第一角画法 (FIRST ANGLE PROJECTION)	比例 (SCALE) 1:1	重量 (WEIGHT) TBDg	材料 (MATERIAL) NR+BR(R5604-H60)	产品号 (PRODUCT NO.) C114360-CPSJ
热处理·表面处理 (HEAT TREATMENT. SURFACE TREATMENT)			名称 (NAME) 前下稳定杆衬套 ⓐ (前稳定杆衬套)

批准 (APPROVAL)	标准化 (STD.)	审核 (AUDITOR)	校对 (CHECKER)	设计 (DESIGNER)	项目组 PROJECT TEAM	图号 (PART NO.)
				马传德 2025.8.27	Stabilizer System 稳定杆系统	Z6012661 ⓐ (WYDL30)

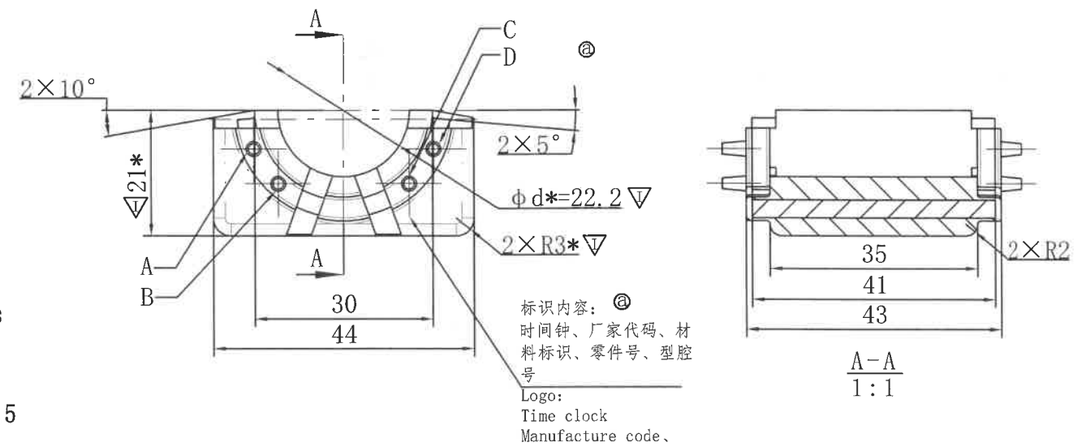
No.	客户版本号 (CUSTOMER VERSION)	No.	变更标记 (MARK CHANGE)	更改内容 (CHANGE CONTENT)	中鼎版本号 (ZD version)	日期 (DATE)	责任人 (RESPONSIBLE)
				Initial Release(初始版本)	A	20250120	马传德
SJ-254690			ⓐ/6	产品更新为下半个衬套，性能测试条件更新，更新产品名称，更新图号，增加刻字内容。	B	20250826	马传德
